8802-3/802.3 REVISION REQUEST

REQUESTED REVISION:
STANDARD: IEEE Std 802.3ab-1999
CLAUSE NUMBER: 40C.2.1 and Figure 40C-2
CLAUSE TITLE: Auto-Negotiation Transmit state machine add-on
for 1000BASE-T

Figure 40C-2 as modified by Revision requests 1042 to 1049 - Changes annotated

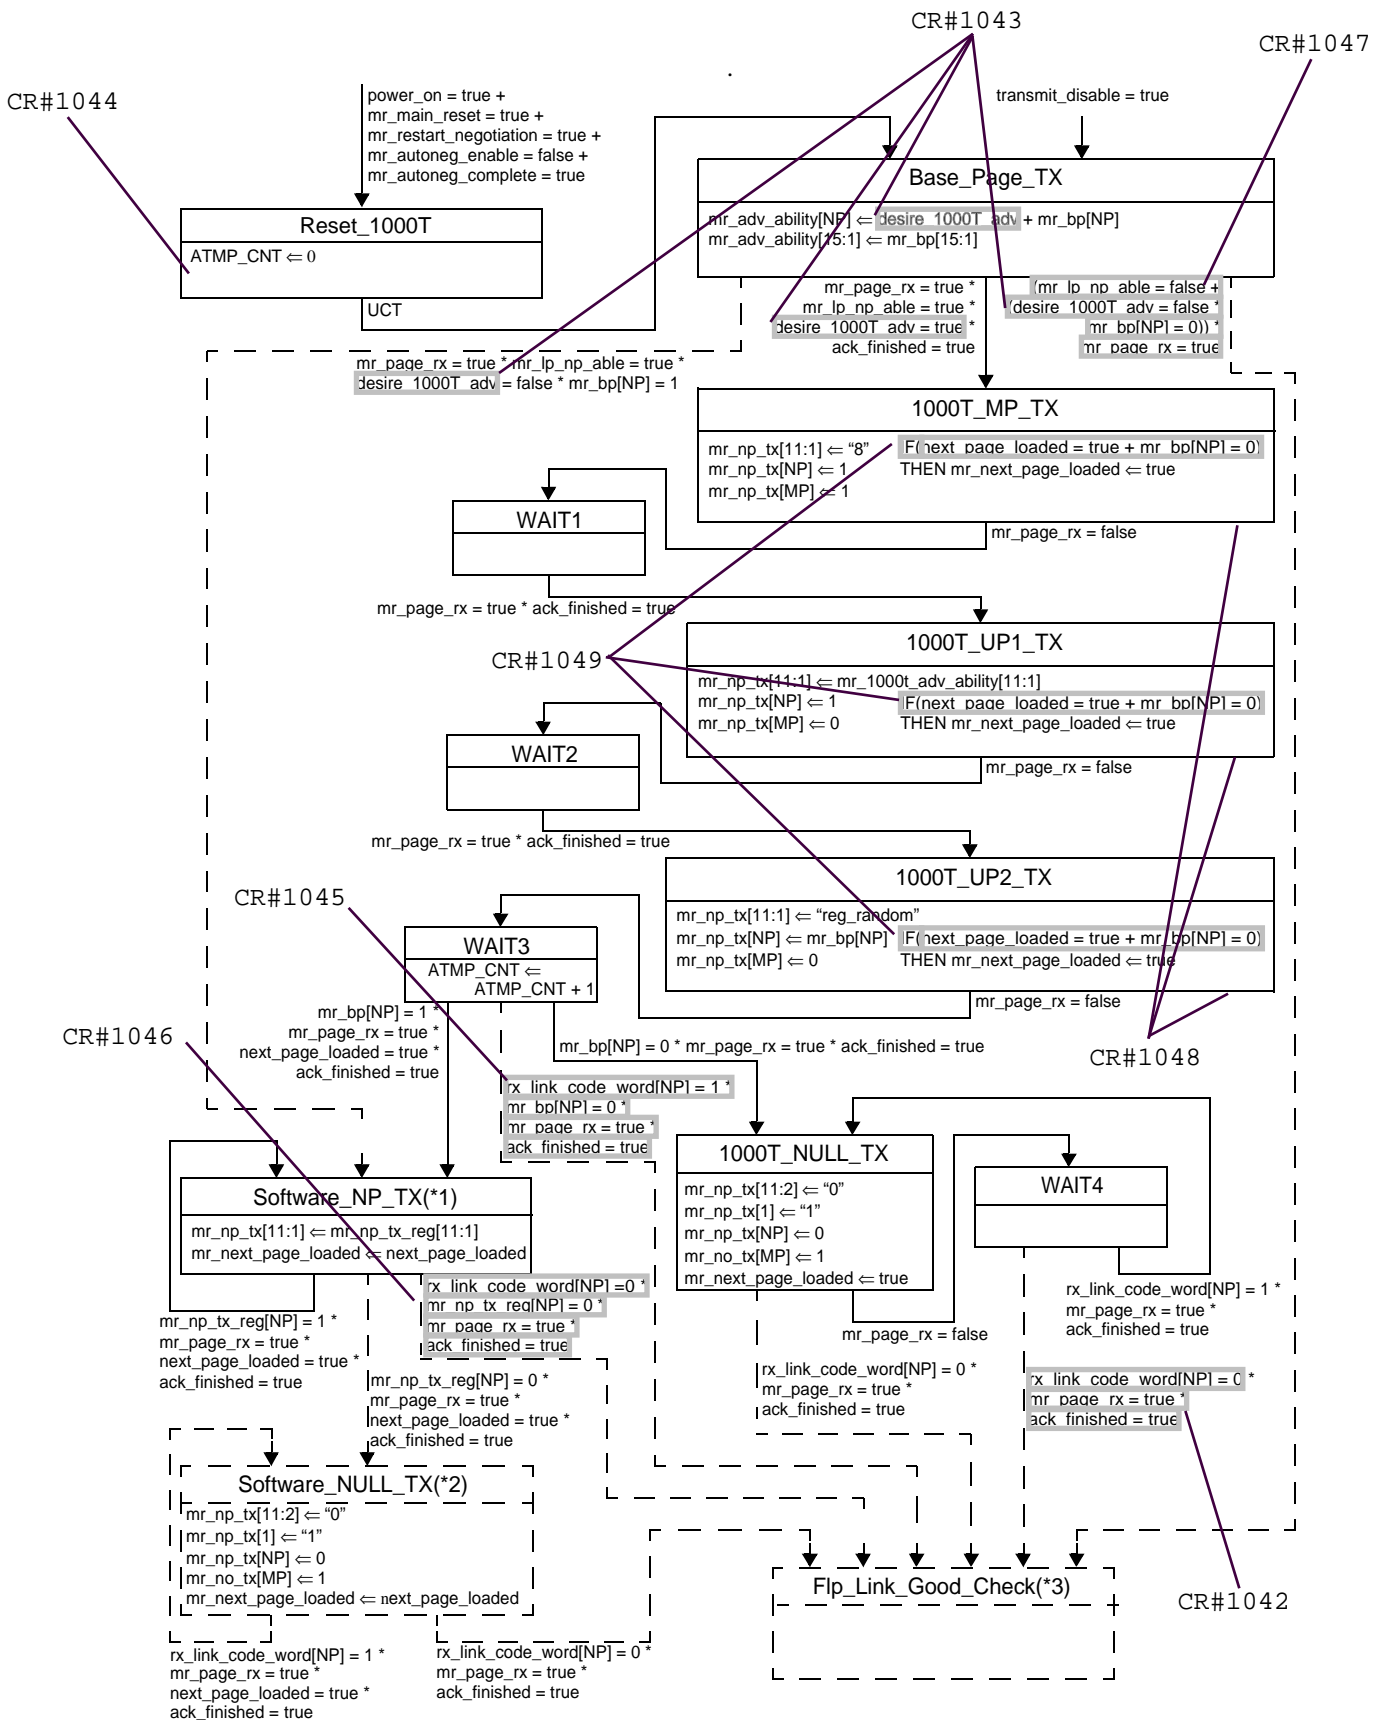
In the states 1000T_MP_TX, 1000T_UP1_TX, and 1000T_UP2_TX
in Figure 40C-2 replace

mr_bp[NP]=1 * mr_lp_np_able=true * np_loaded=true) + (mr_bp[NP]=0 *
mr_lp_np_able = true)

with

(next_page_loaded=true) + (mr_bp[NP]=0)
